Subject: FW: FW: Planning Consultation on: BN/57/20/DOC

Please upload onto Ocella the email trail below and the attachment from the **applicant** regarding discharge of condition application **BN/57/20/DOC** for the Lillies, Yapton Road, Barnham.

Please see the email below from ADC Drainage Engineers to discharge of condition application **BN/57/20/DOC** regarding The Lillies, Yapton Road, Barnham.

Outstanding comments

Storage Structures for Storm

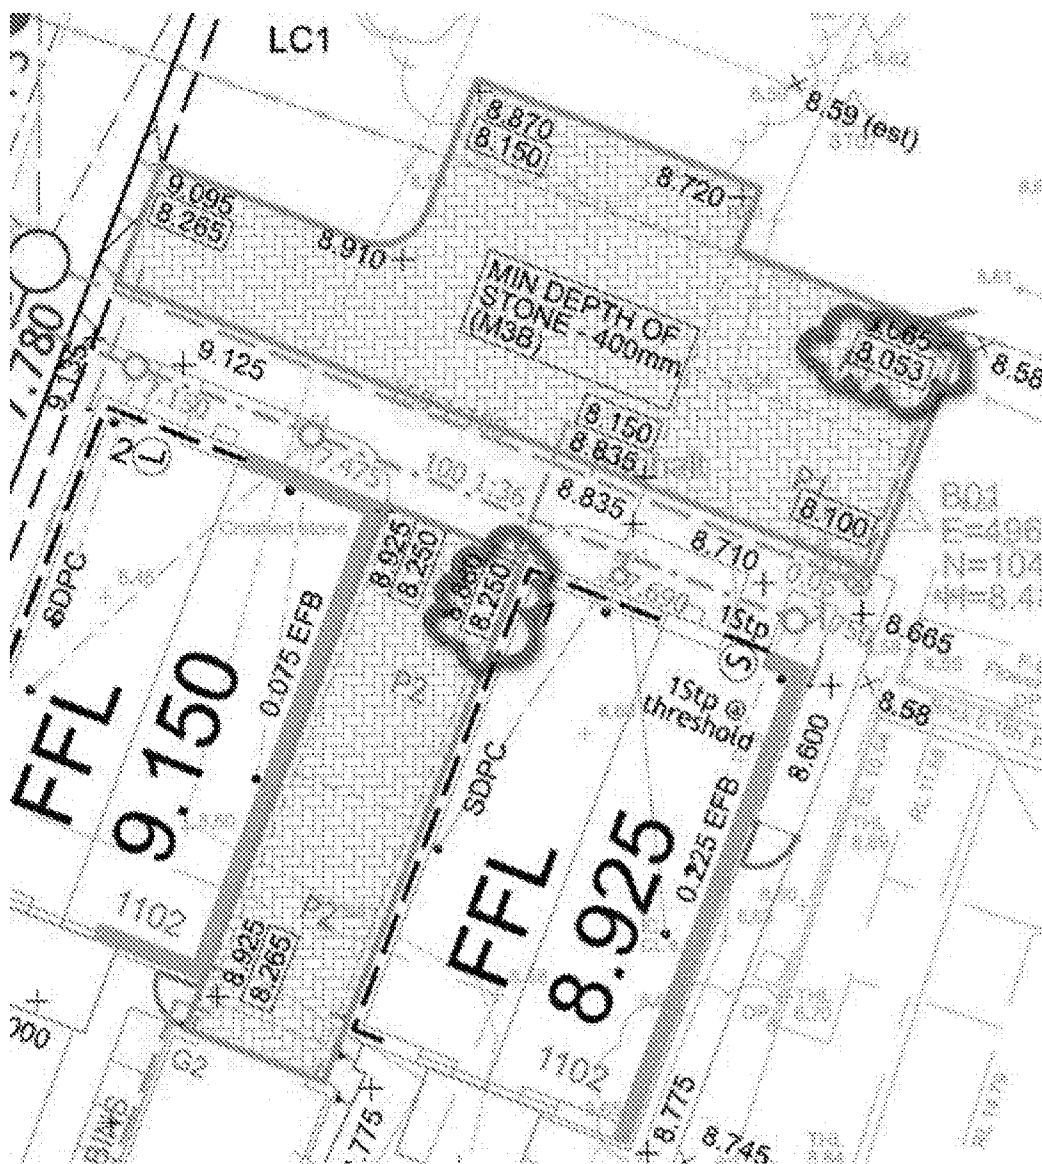
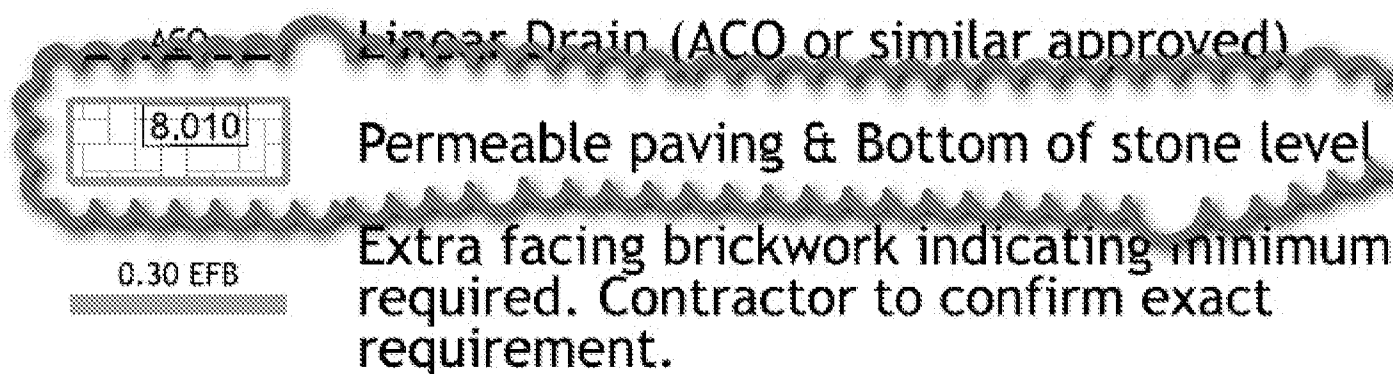
2. (Condition 6- 2) Surcharged outfall details not included in latest calculation printout. Flooding predicted at downstream nodes, will the flooded volume be safely contained on site? Please provide an updated exceedance flood plan. Refer to the file "SWS-Surcharged Outfall Results Only.pdf" issued on the 06/08/20. The flood water is nominal and will not impact upon dwellings, nor impact on safe access/egress. The flood routing plan attached but this was covered in the last correspondence.
3. (Condition 6- 4) Invert level of car park node 3b shown to be 8.053 in calculations, this does not tally with plans. Please update to ensure consistency. See below extracts from the submitted info. There are no inconsistencies

Invert level of car park node 3b shown to be 8.053 in calculations, this does not tally with plans. Please update to ensure consistency.
